ADDENDUM NO. 1

UNIVERSITY OF SOUTH CAROLINA BEAUFORT CENTER FOR THE ARTS RENOVATION STATE PROJECT NO. H36-9518

June 8, 2017

PERFORMANCE SOUND - FACEPLATES

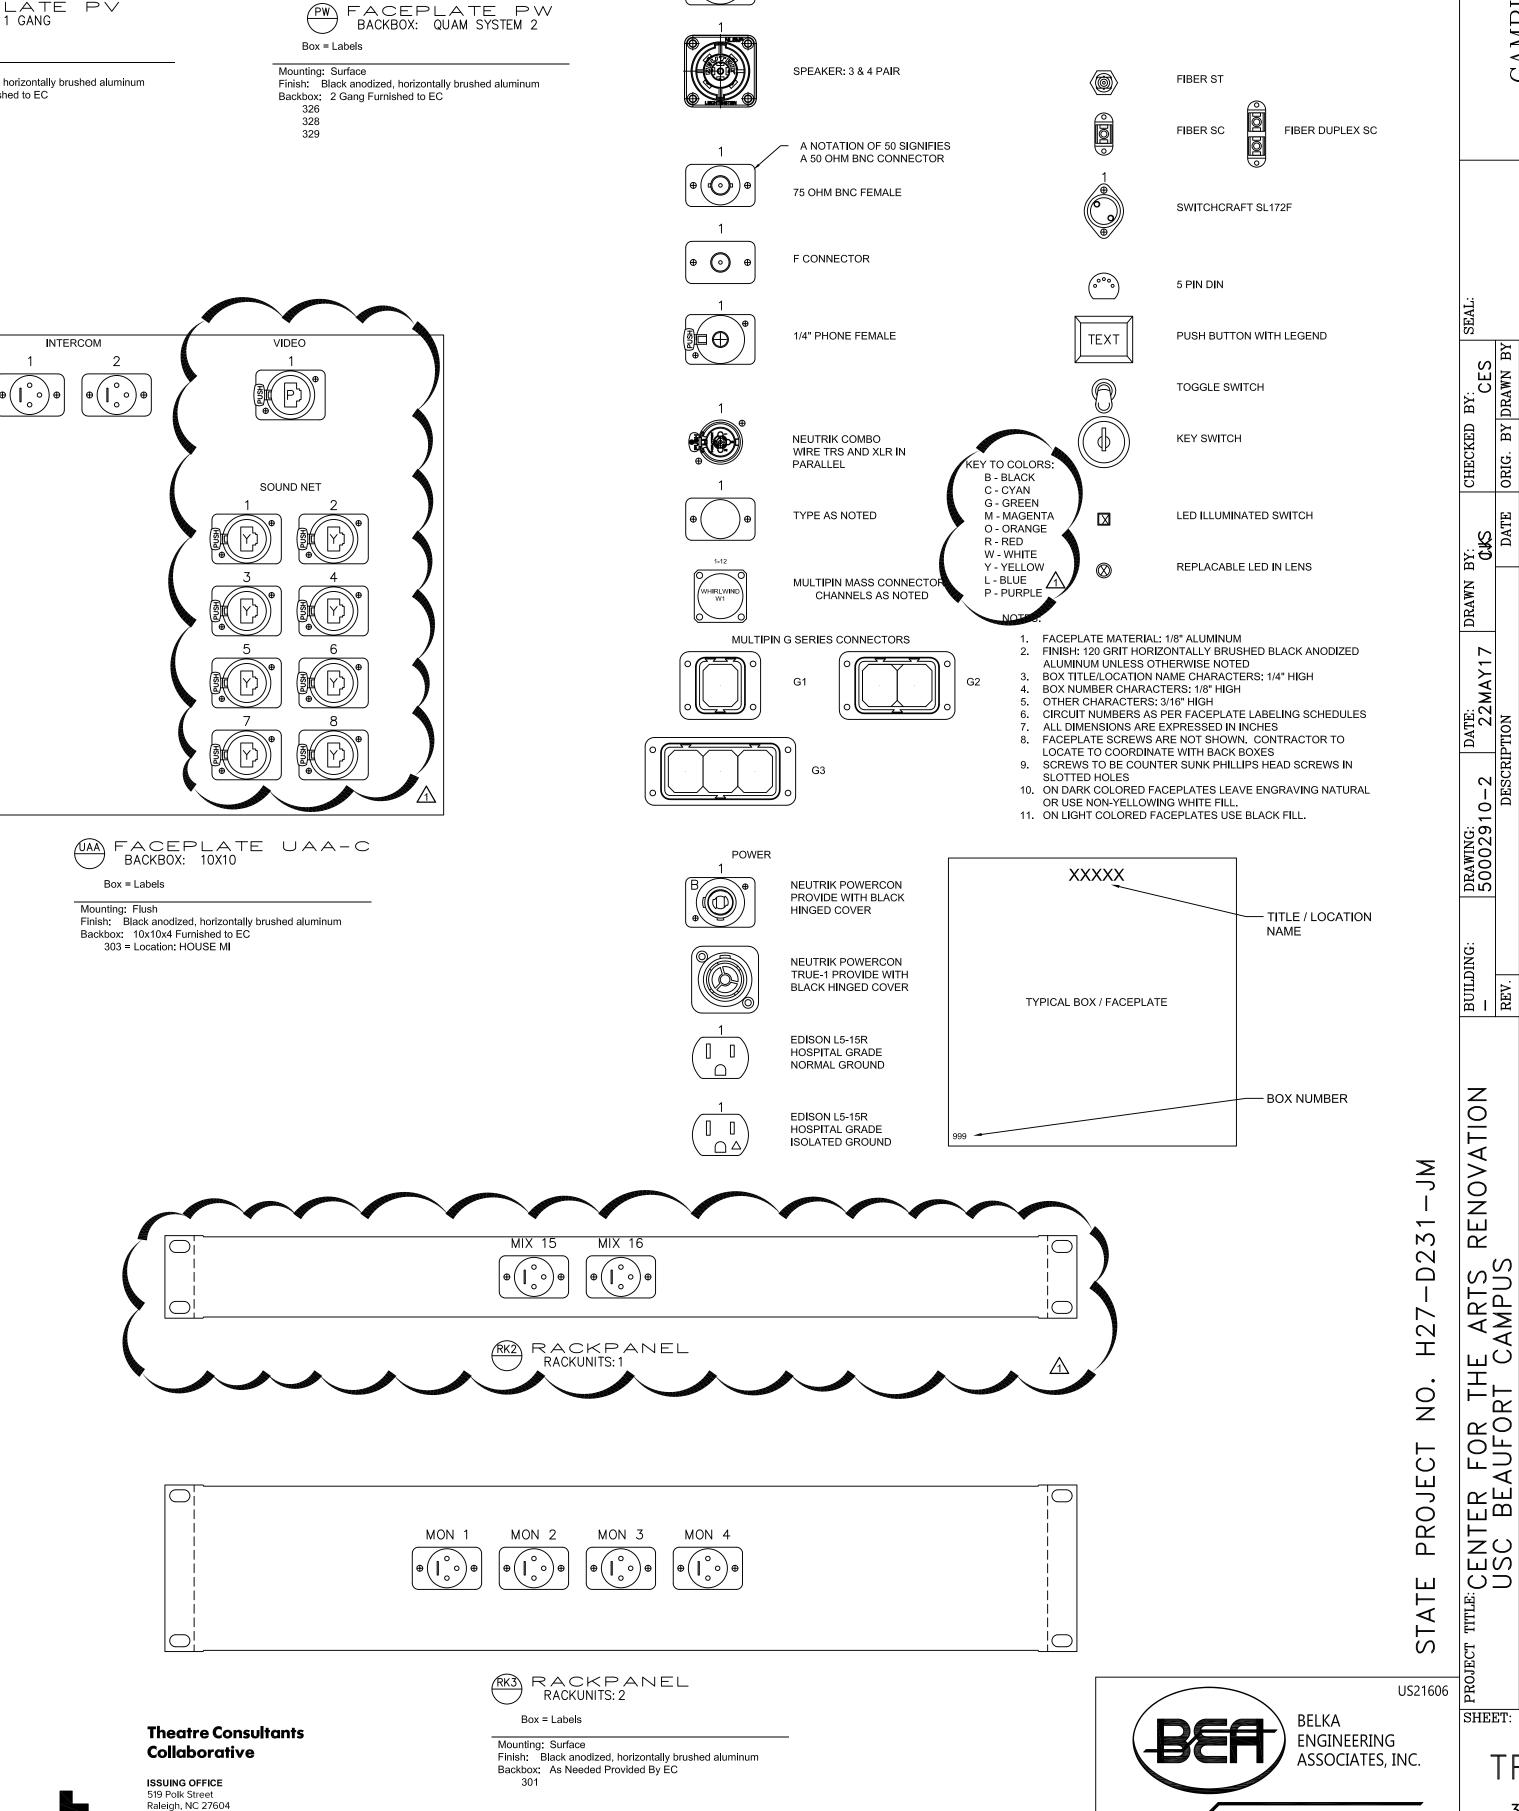
- A. Drawing TPS2.0
 - 1. Change video jacks to purple.
 - 2. Change Soundnet jacks to yellow.
- B. Drawing TPS3.0
 - 1. Noted that critical patches use red patch cords.
 - 2. Changed PC label to read "Media PC"
 - 3. Changed Wireless presentation interface to AM-101
 - 4. Deleted ClickShare Dongles
 - 5. Add (2) Satellite receivers (Existing)
 - 6. Add (1) Blue Ray Player (Existing)
 - 7. Add (3) DM HDMI input cards
 - 8. Change Matrix Switcher to **DM-16x16**
 - 9. Add existing preview monitor
 - 10. Added an ethernet link to the campus network
 - 11. Added (1) SOC-4 with output LOBBY
 - 12. Labeled RK1
 - 13. Added RK2 with (2) XLR jacks fed from mixer outputs 15 & 16
 - 14. Change CP3 to CP3N

- 15. Added 8 inputs
- 16. Added 2nd net jack

pbox (TheatreConsultantsCo)\TCC Projects\USCB-16\Drawings\TPS Block.dwg, TPS31, 6/2/2017 5:23:58 PM

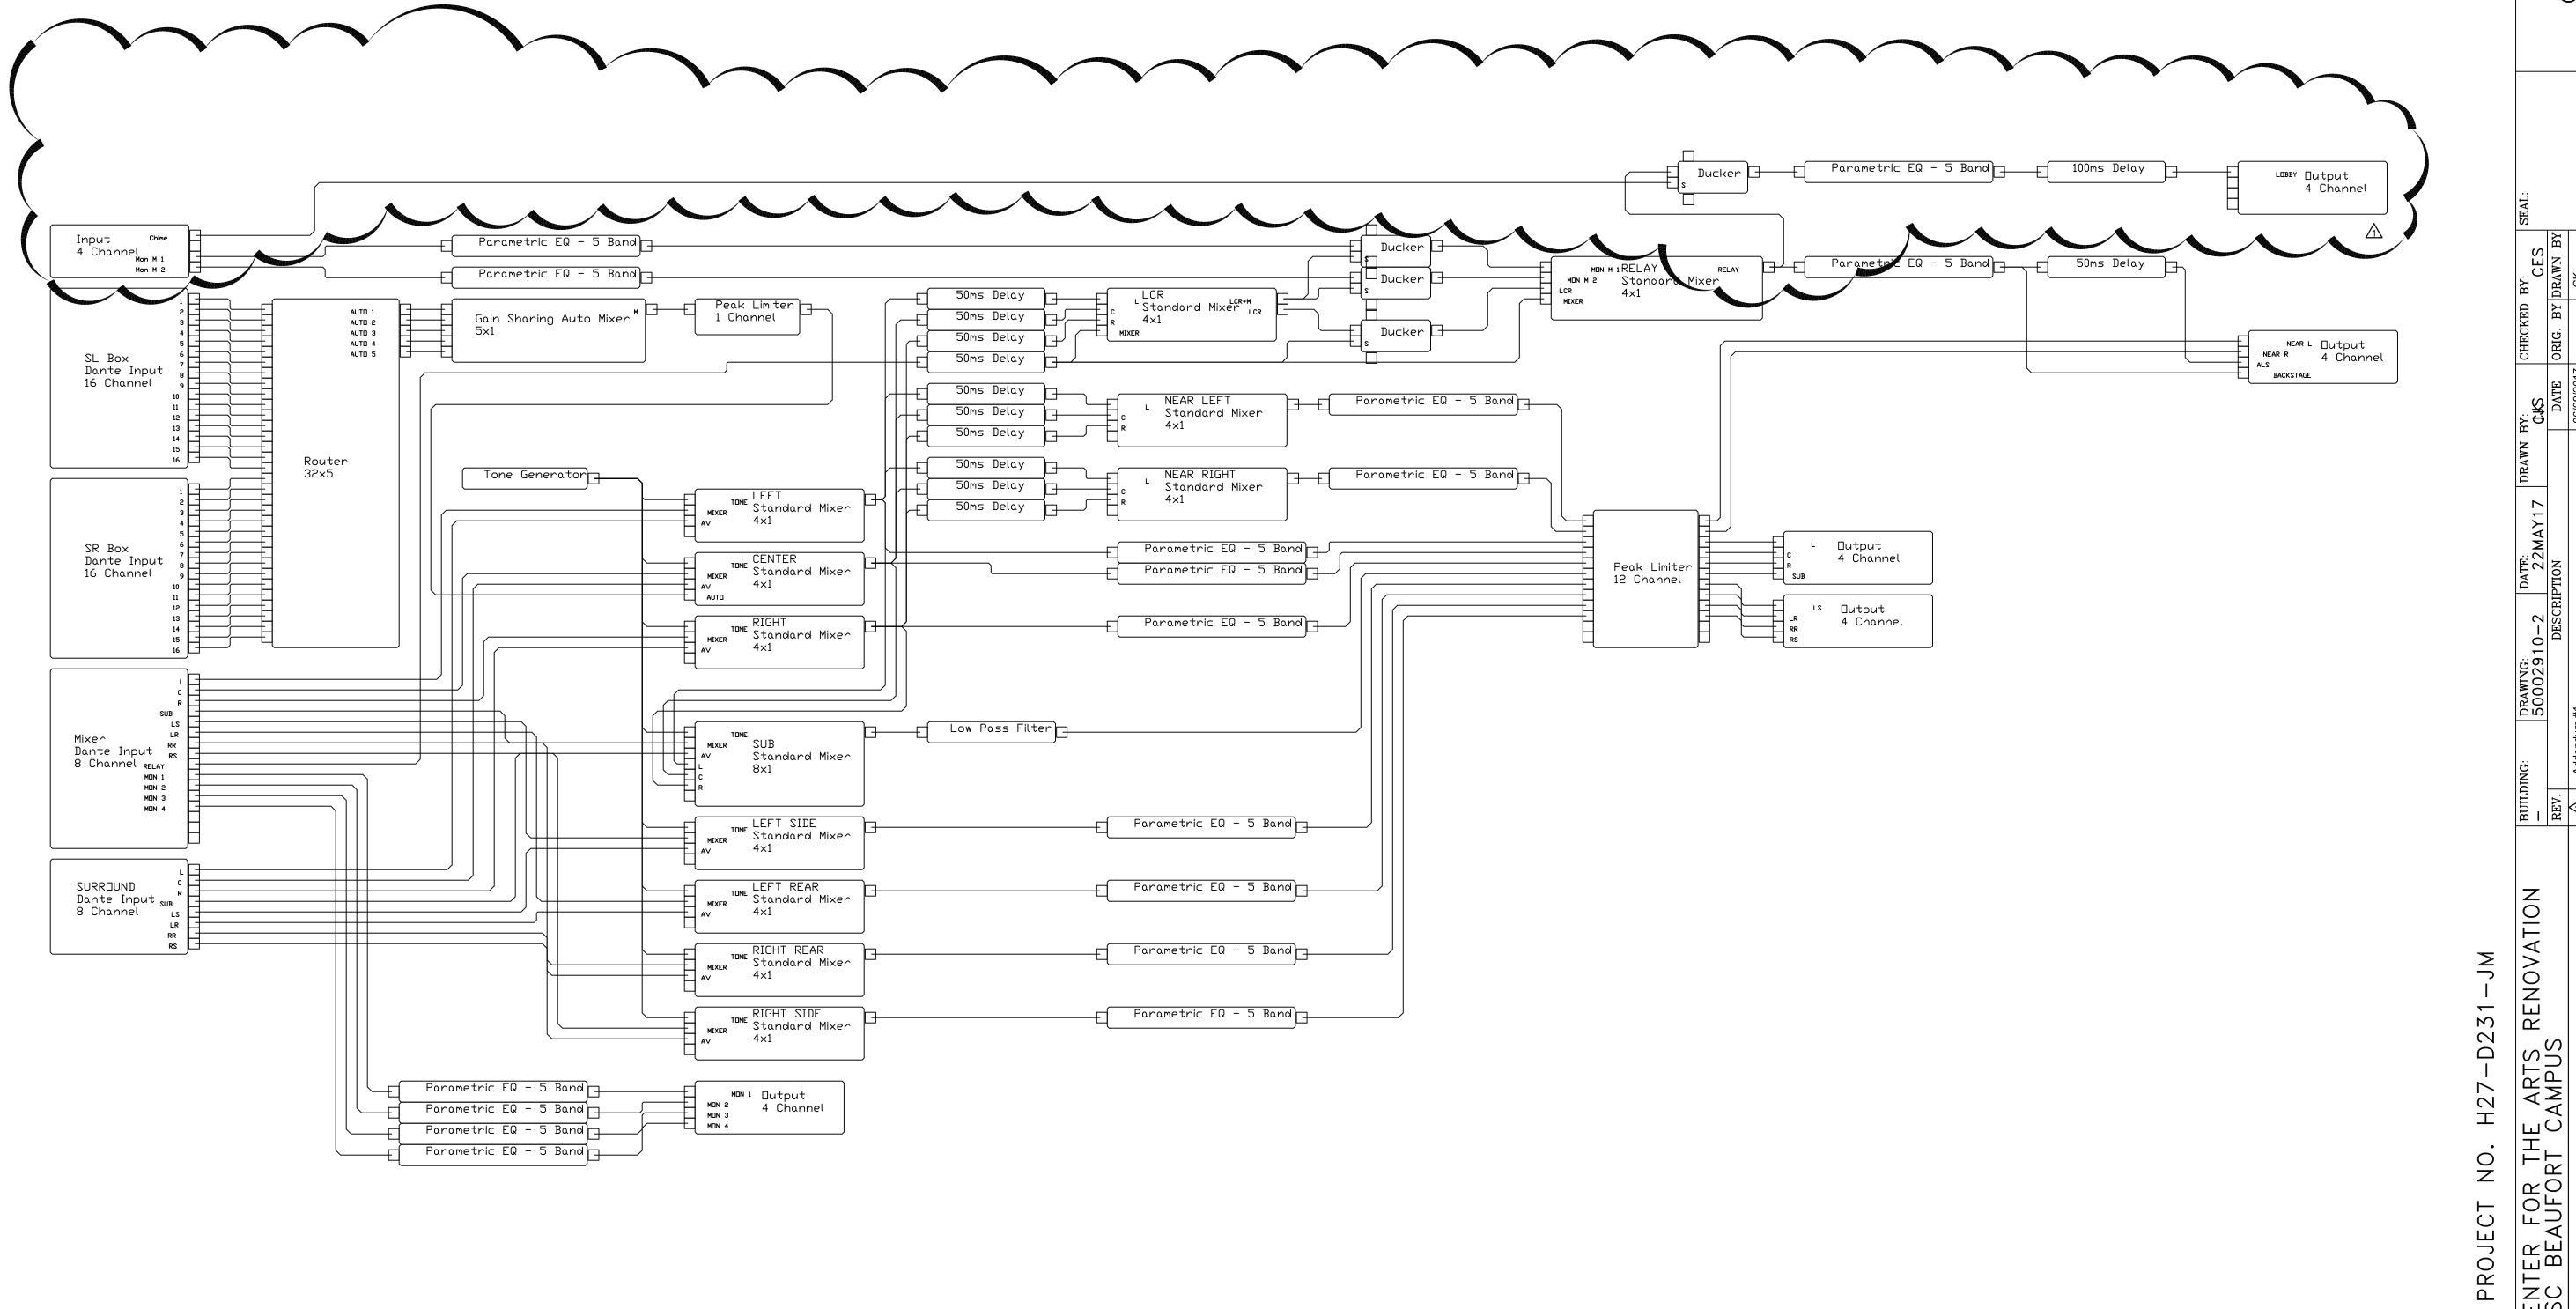
- 1. Added (1) SOC-4 with output LOBBY ran output to amplifier E2:2
- 2. Noted amplifier output 2 feeds existing lobby speakers.
- 3. Labeled RK3

TPS3.2

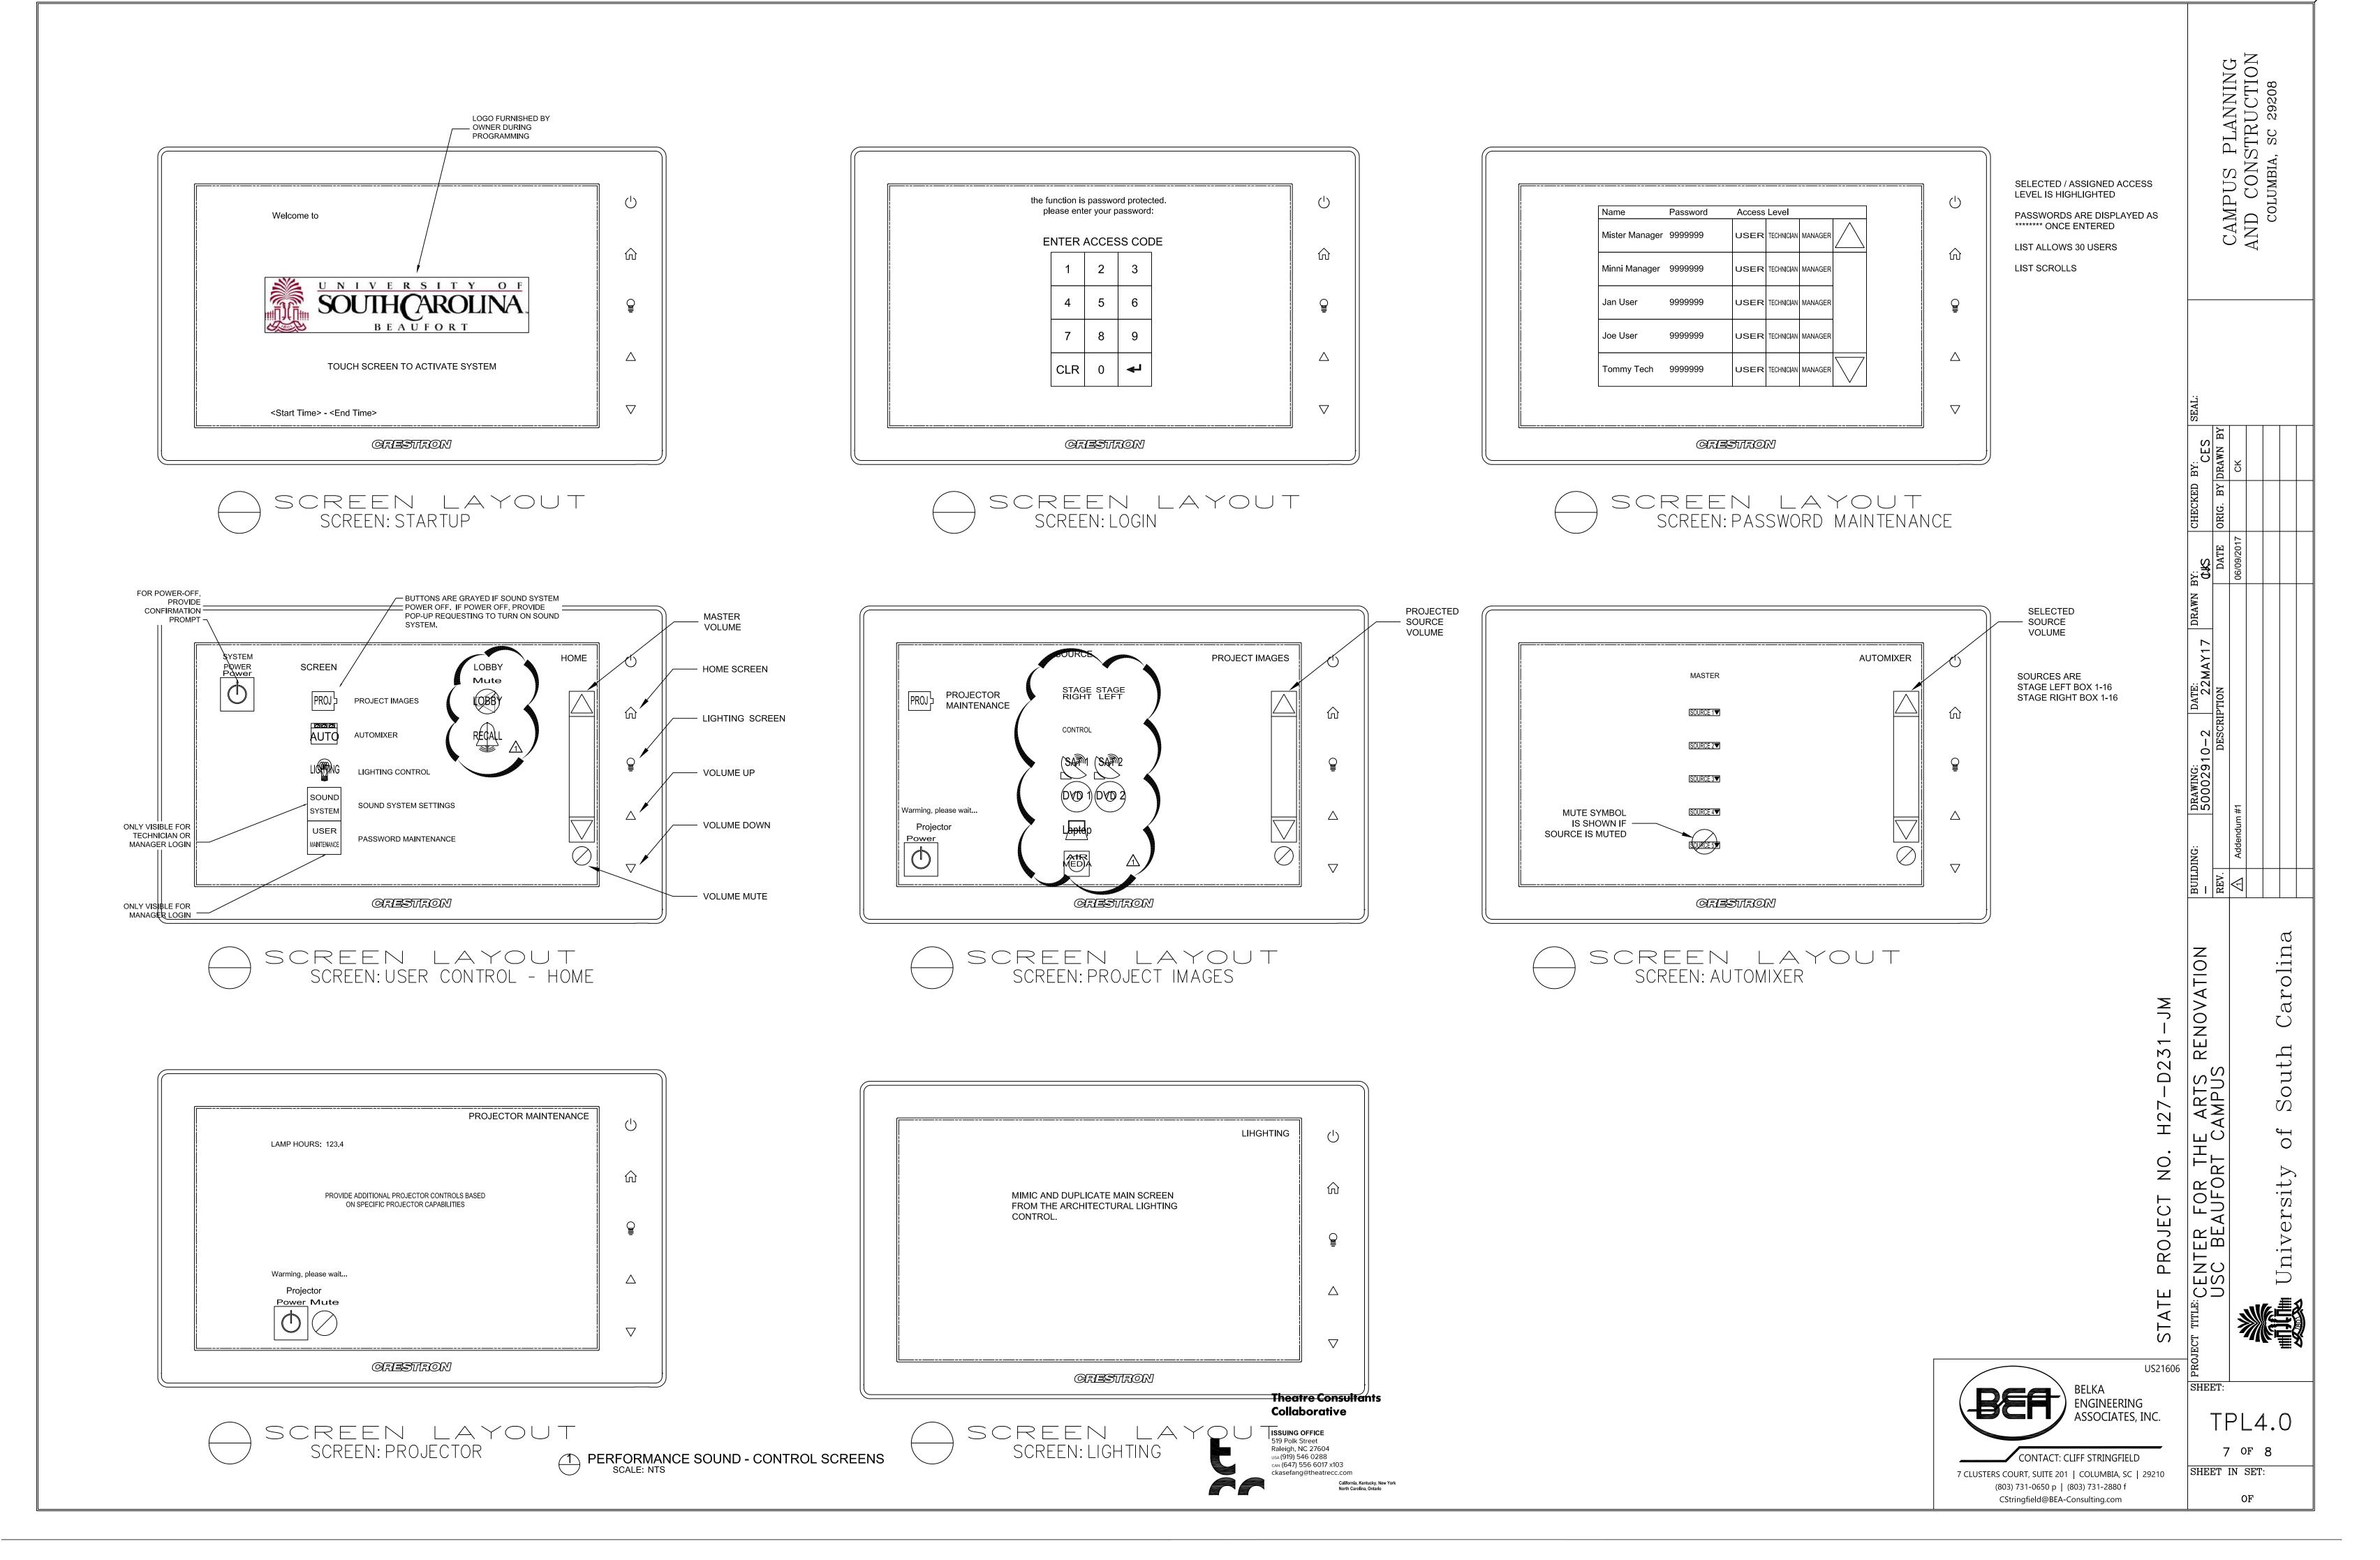
1. Added chime input, feeding the sense side of a ducker. The ducker input is from the aligned relay feed. The ducker outputs to a parametric equalizer and then a delay before it terminates at the lobby output.
